Subject: Calico Solar 08-AFC-13C  
Applicant's Response to CEC Data Requests Set 1 (1-37)

## Applicant's Response to CEC Data Requests Set 1 (1-37)

CALICO SOLAR PROJECT

**Calico Solar**  
**Responses to CEC Data Requests**  
**Data Request Set 1 - Requests 1-37**  
**08-AFC-13C**

**SWR-1**

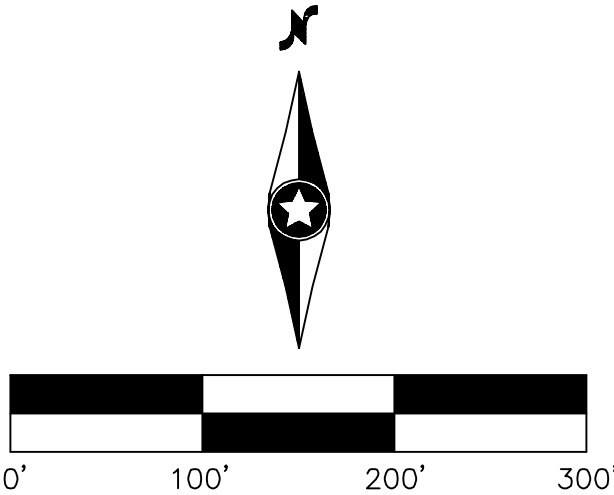
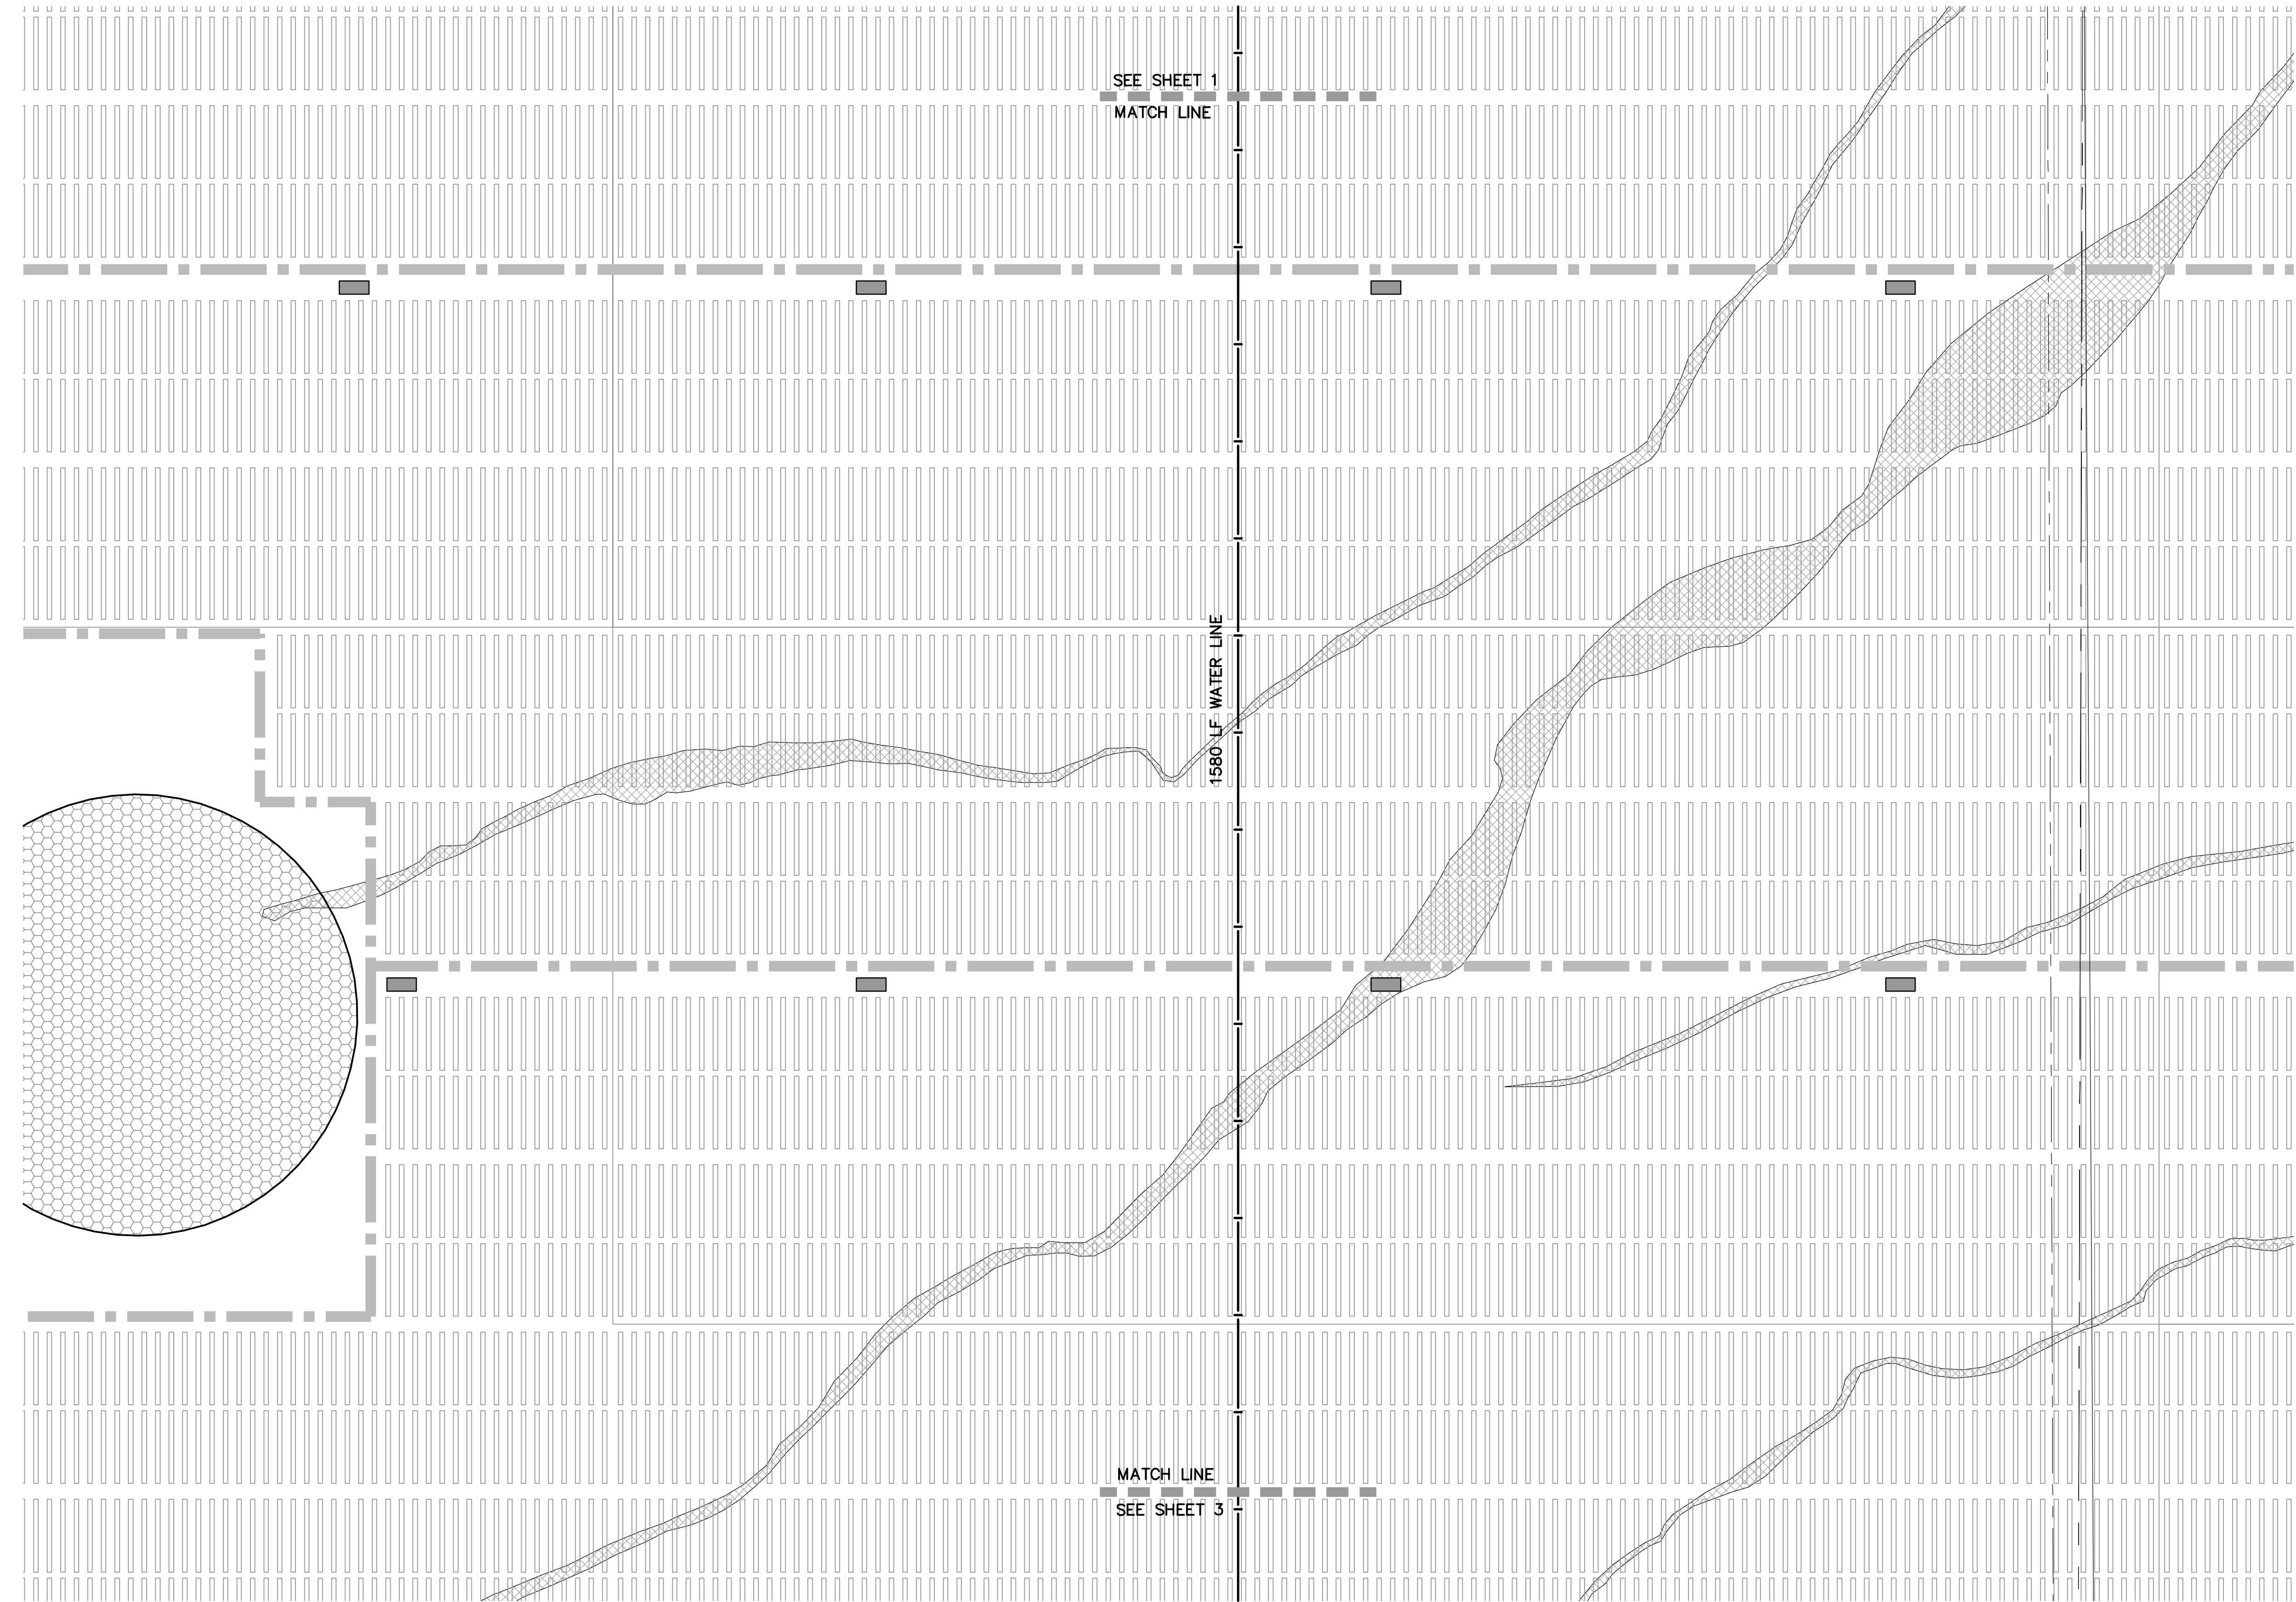
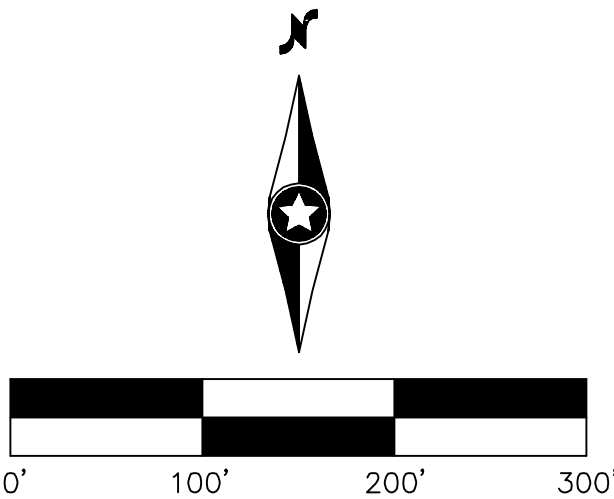
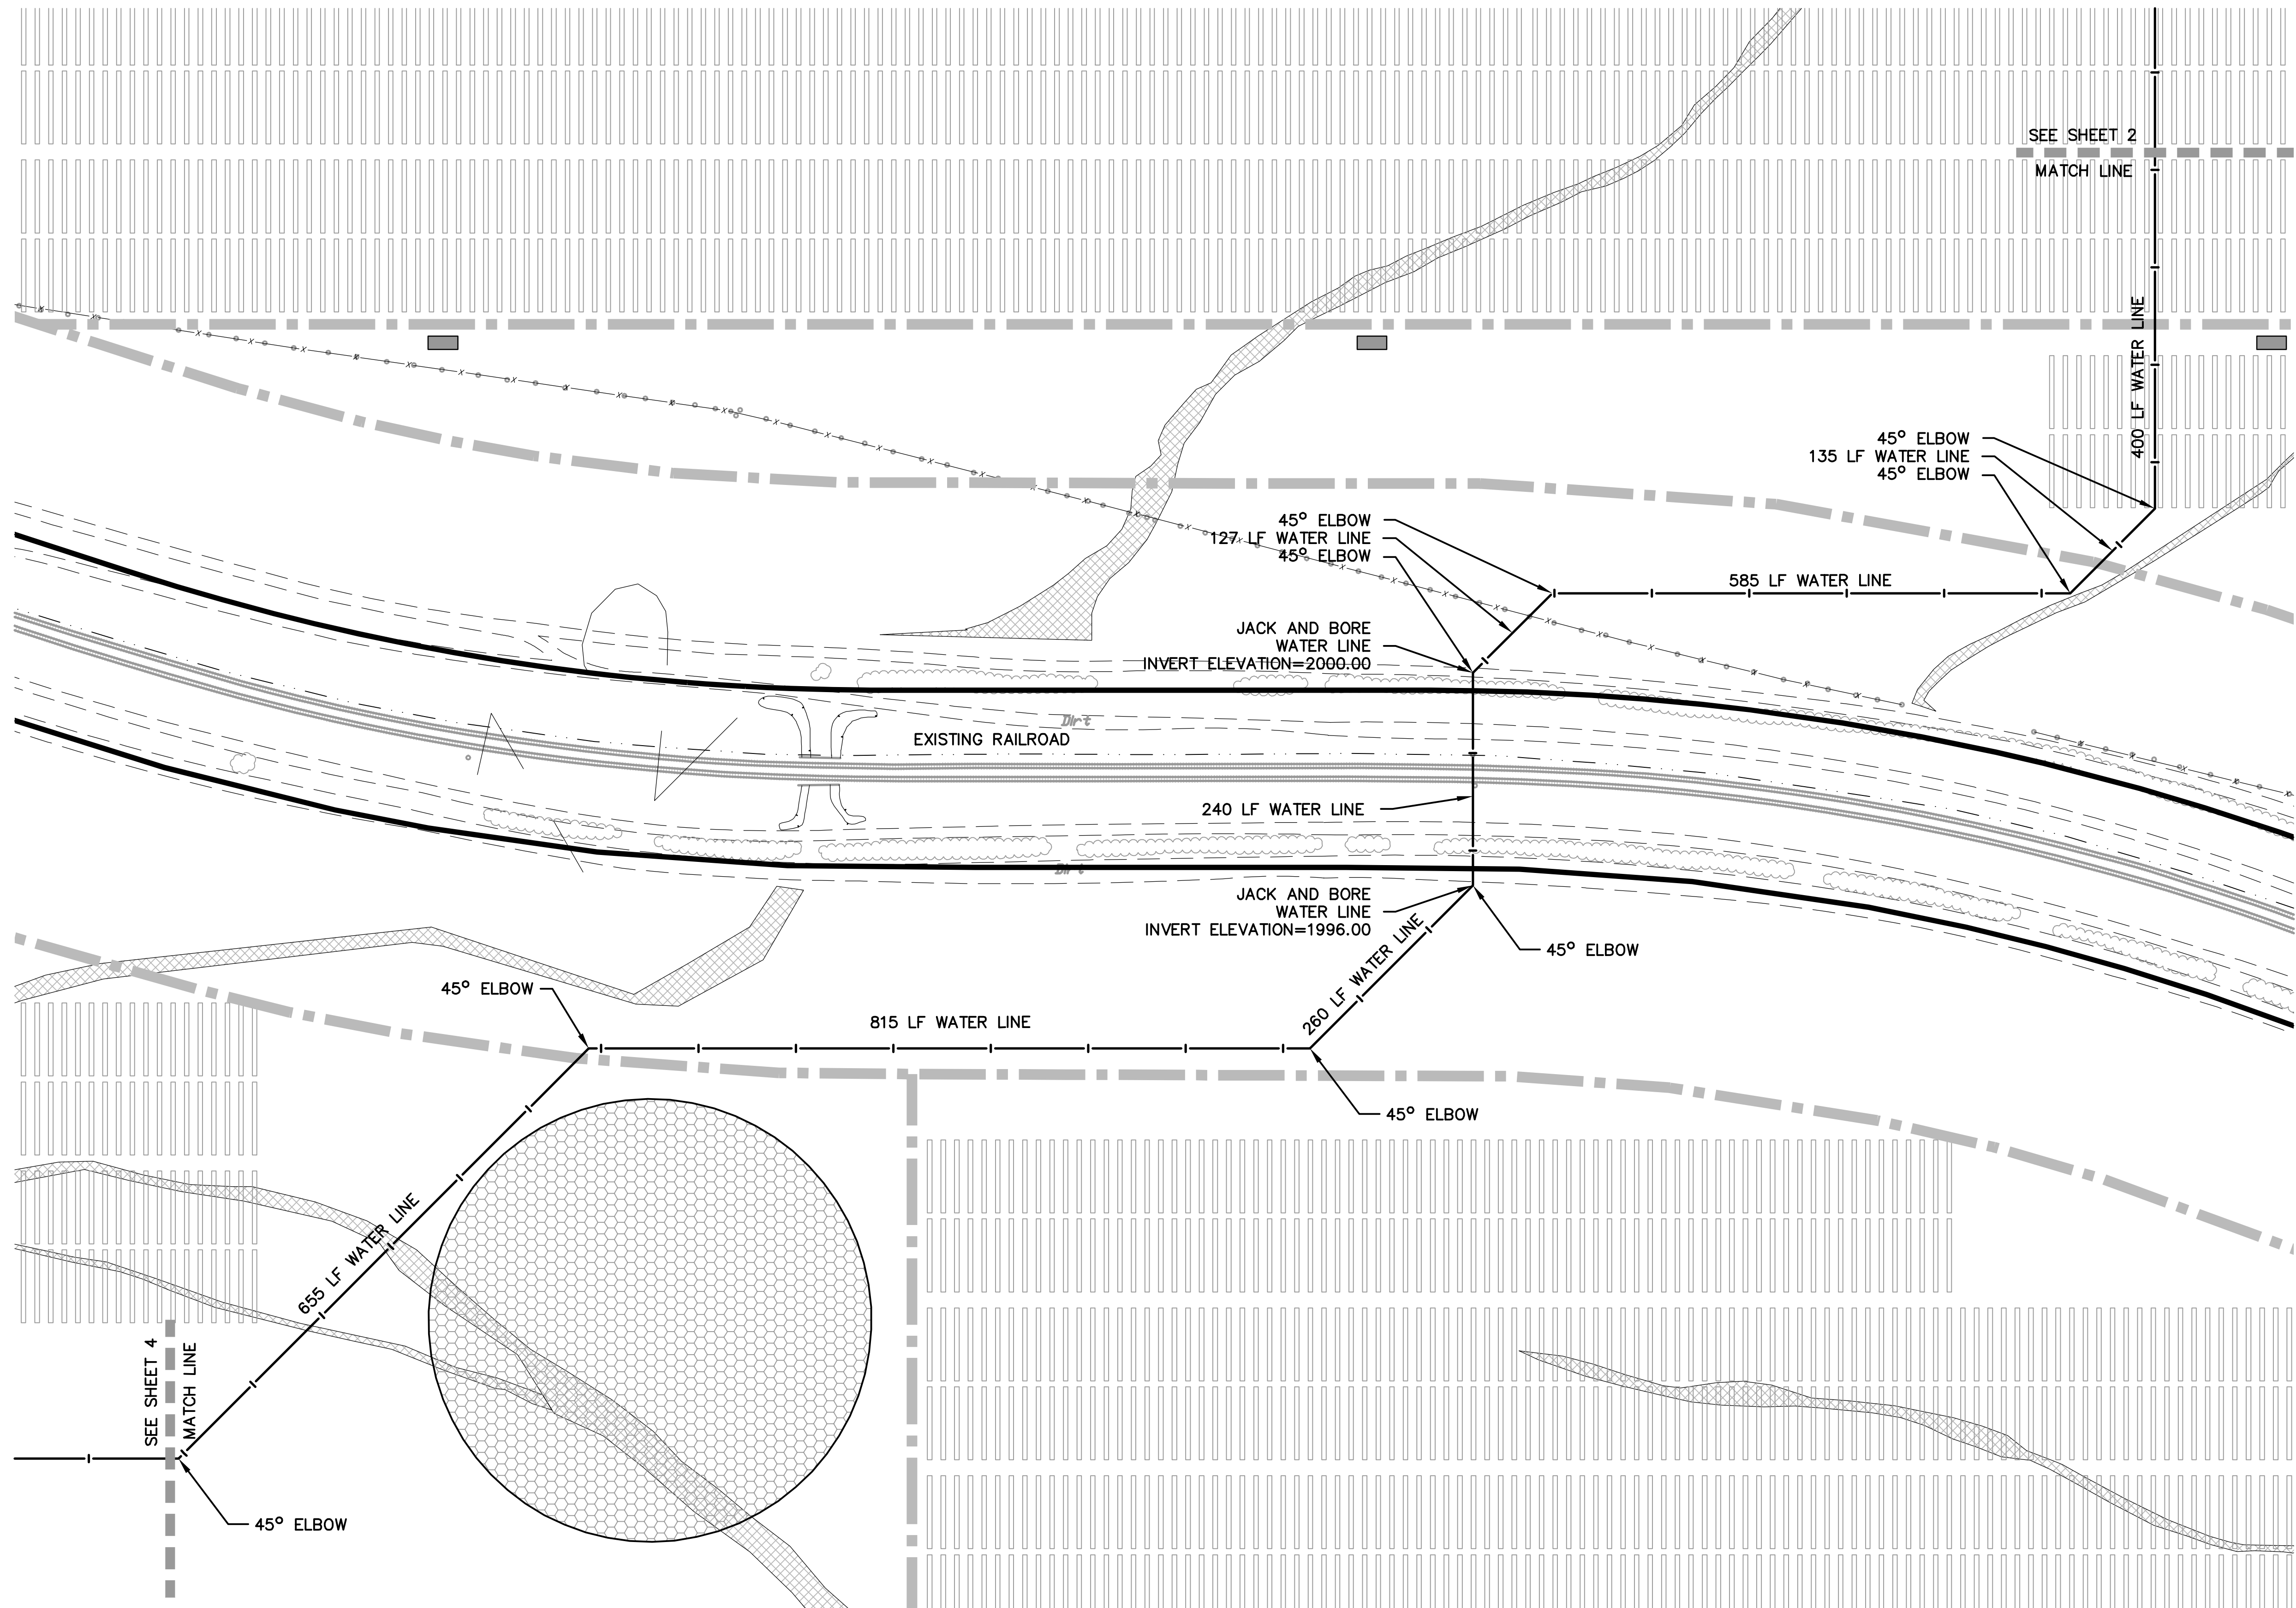
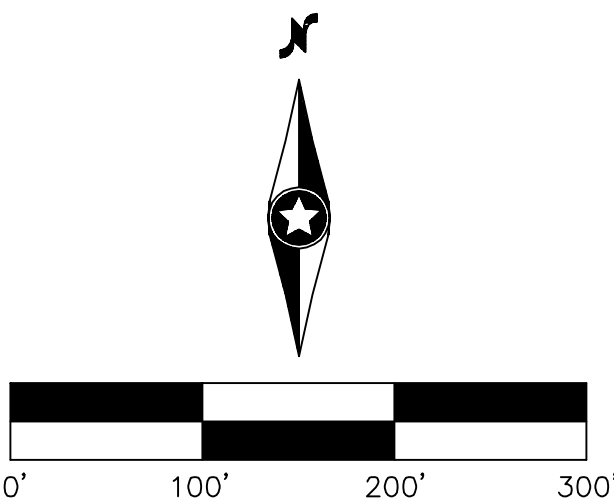
Please provide the construction design of the water line from the well head to the main services complex.

Horizontal plan views of waterline from the connection to the existing well to the Main Service Complex and details of the typical trenching and thrust blocking have been included (please see attachment SWR-1).
